工程指示 / 要求簡箋(E.I.)

工程指示編號：EI / 8052 / 24 修改版次：-
 工程編號 : J - 858 工程名稱 : 將軍澳日出康城 LP 11
 工程項目 : 後加百葉 T1 (11/F) 補 1 隻
 收件人 : 生統 發件人 : Paul Wong 日期 : 15/07/2024

美特铝质有限公司 MIDI Aluminium Fabricator Ltd.		工程號 J858 地盘 康城11期 图纸名称 百叶窗组装图	類別 制圖 I. H. 復核 - 批准 -	物料號 - 2024-05-09 - -	圖號 J858-AL-41SU 數量 - 單件重量 - (KG)
修改日期	採用工廠	地盘	材料	材料颜色

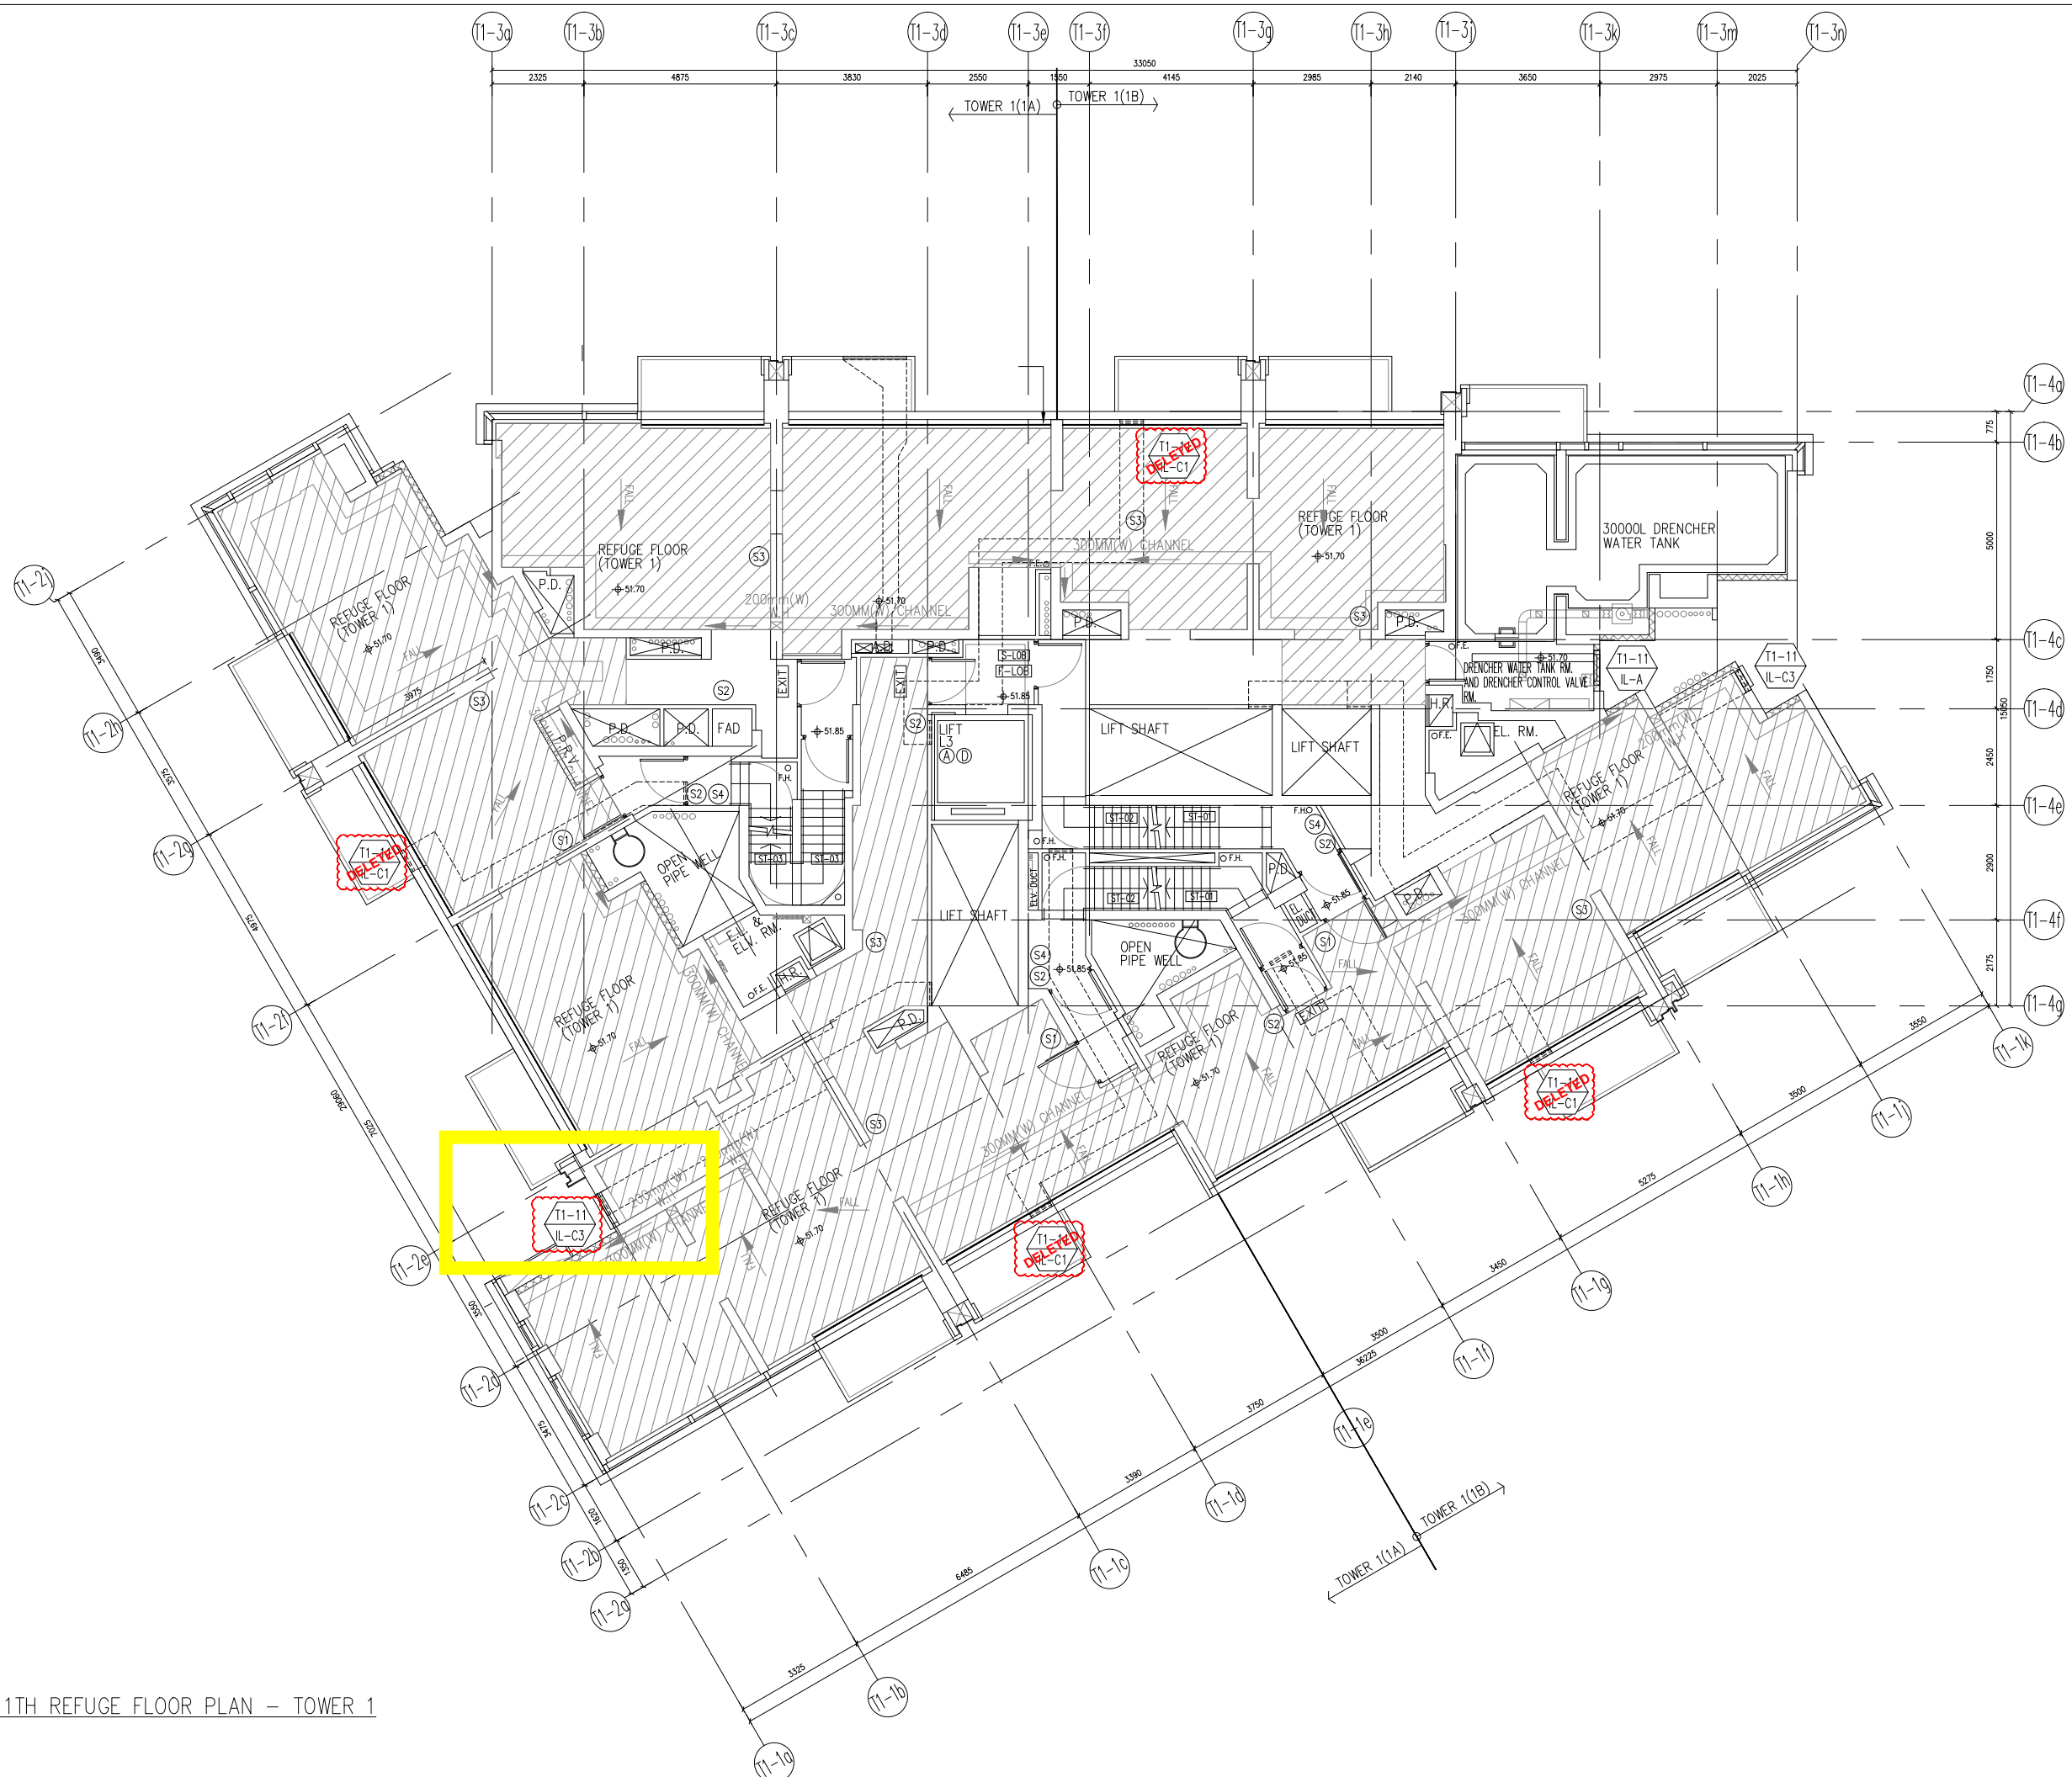
1. 請生產 1 隻百葉送地盆安裝。 T1 11/F / IL-C3。
2. 請查鋁料是否足夠??
 如 B1502 鋁巴無料，用鋁板代替
 X86251 無料。用 X86157 改料代替
3. 按地盤要求: T1 用 11/F T1 AB Kit ，請加做一隻。SO: 425 W X 1250 H

加一隻 T1 作
用於 AB 吋厚

DWG NO. : J858-IL-3102 REV. : A

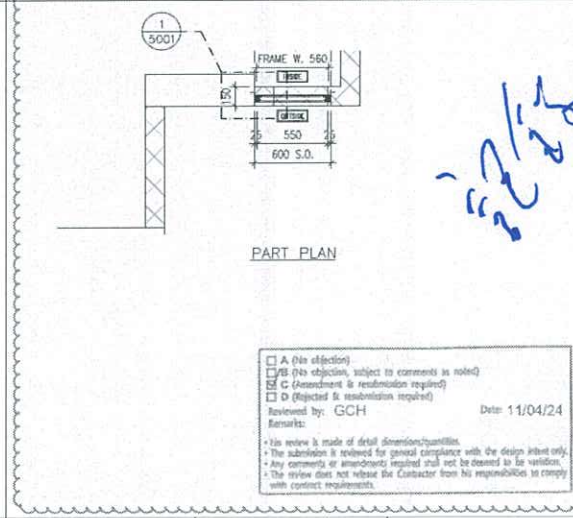
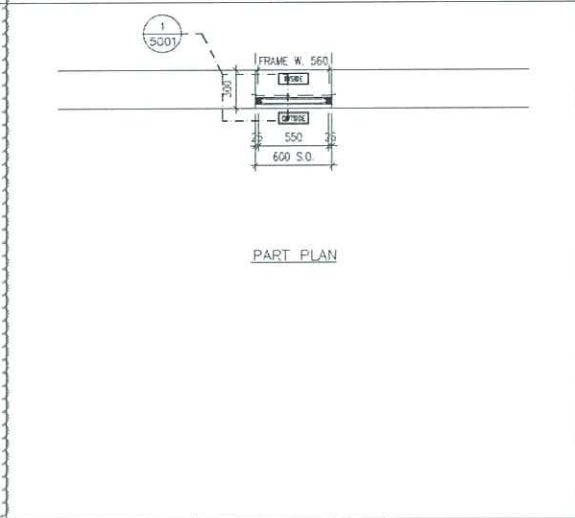
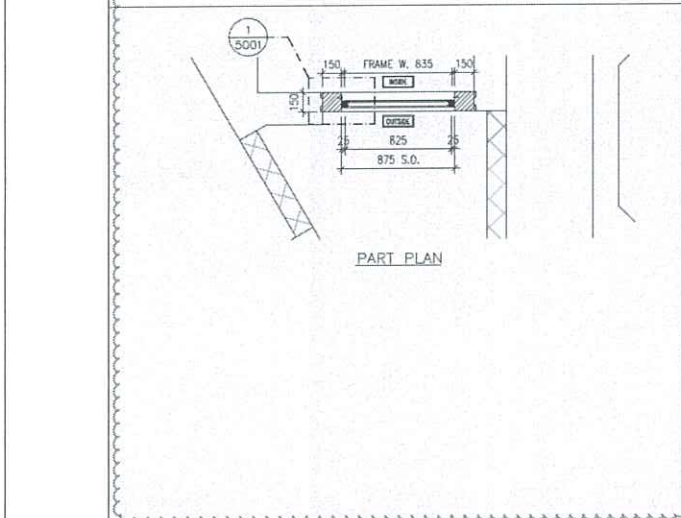
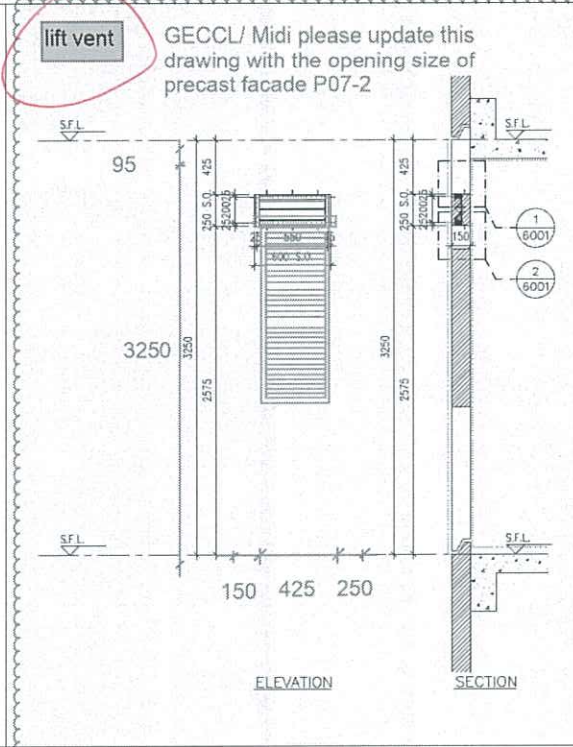
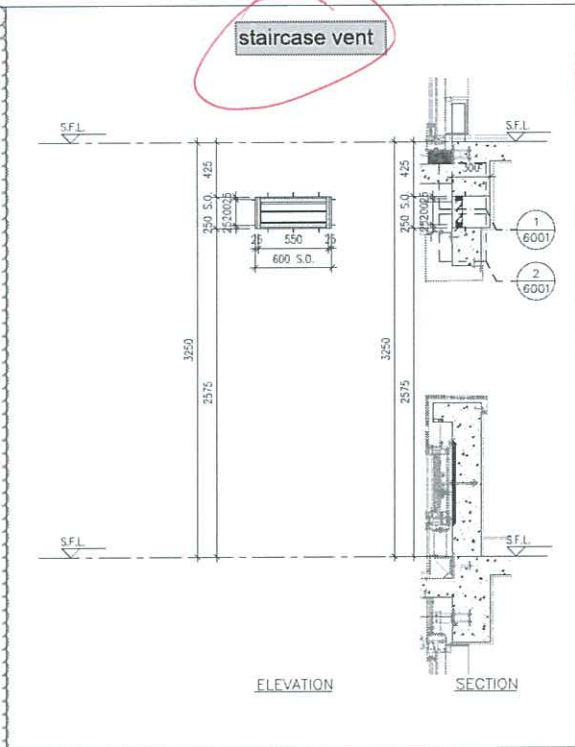
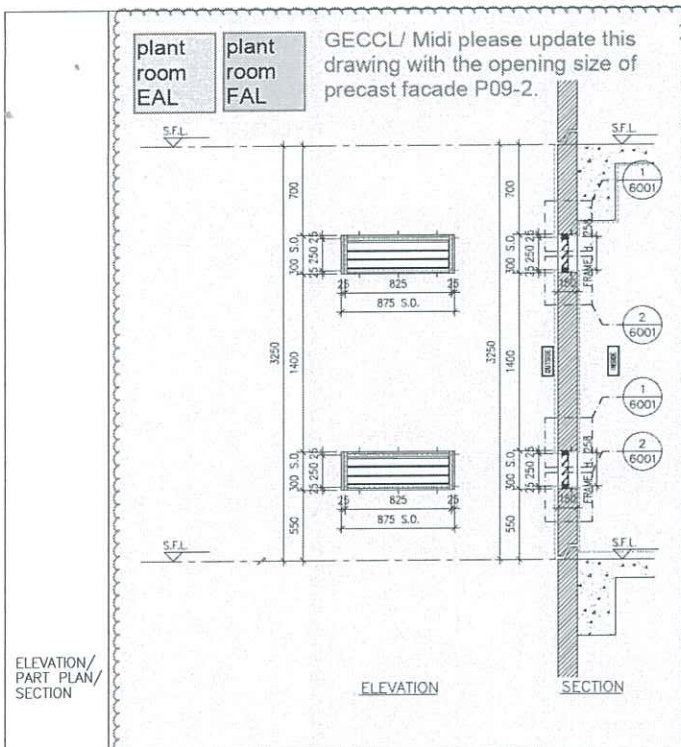
T1 AB 11/F
425 W x 1250H
